MultiPlus-II/EasySolar-II/Quattro-II Current Sense socket issue

Tech note – December 2021 - rev 4

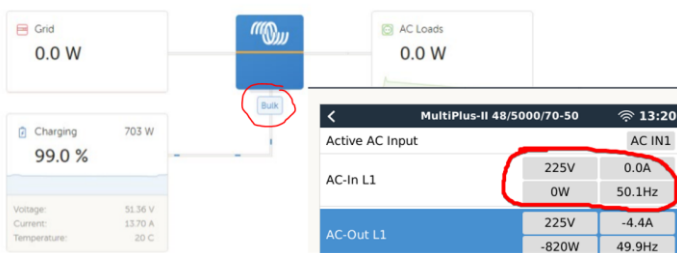
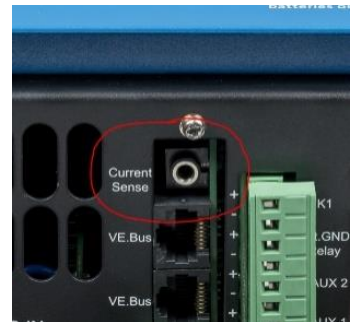
All MultiPlus-II, EasySolar-II and Quattro-II models, featuring the audio jack type socket as shown on picture on upper right of this document, can be affected. The problem does not occur often, but is hard to recognise in case you are not aware of the possibility – while simple to solve.

On newer models, the audio-jack socket used as a connector has in newer models been replaced by a 3-way standard connector with a wire bridge.

3.5mm audio jack (OLD - affected)

3-pin connector (NEW – not affected)

This table shows per which serial numbers the product has the new Current Sense connector:
